McCULLOCH SERVICE BULLETIN

NO. 1595

MODEL 10 Series, PM 55, SP 60 & SP 81 DATE December 24, 1975

SUBJECT Breaker Box, P/N 84329.

Figure 1

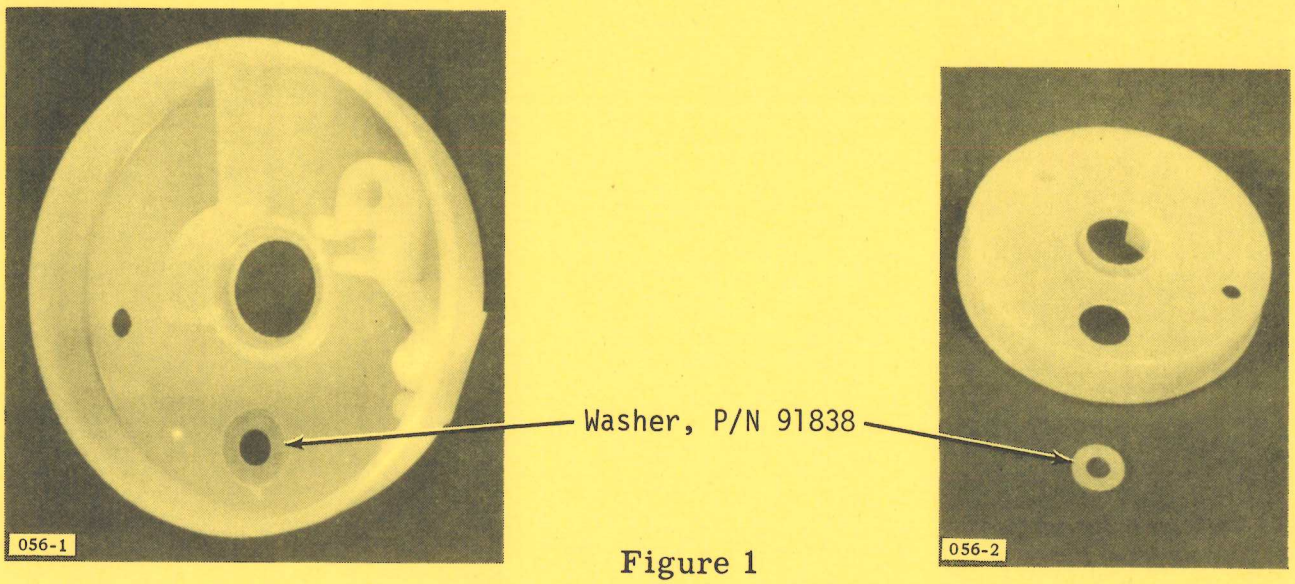
The above listed model saws are now being manufactured with an improved breaker box assembly. The improvement is a modification of the breaker box which allows the addition of a washer under the ignition breaker assembly at the adjustment end (see Figure 1).

The addition of the washer, P/N 91838, results in a metal to metal contact between the breaker point assembly, the washer and the cylinder which greatly reduces the possibility of the points shifting and changing the timing.

To aid in locating the washer before installing the breaker box and to provide a seal around the washer, apply a very light film of RTS Silastic (P/N 110083) on side of the washer. Place the side of the washer with the film of Silastic down on the cylinder then install the breaker box. When the breaker points are tightened down, the Silastic film will spread out and provide a good seal. If any excess Silastic is visible in the point box, wipe it out.

Shipments of breaker boxes will be made under, P/N 92025, which includes Washer, P/N 91838.
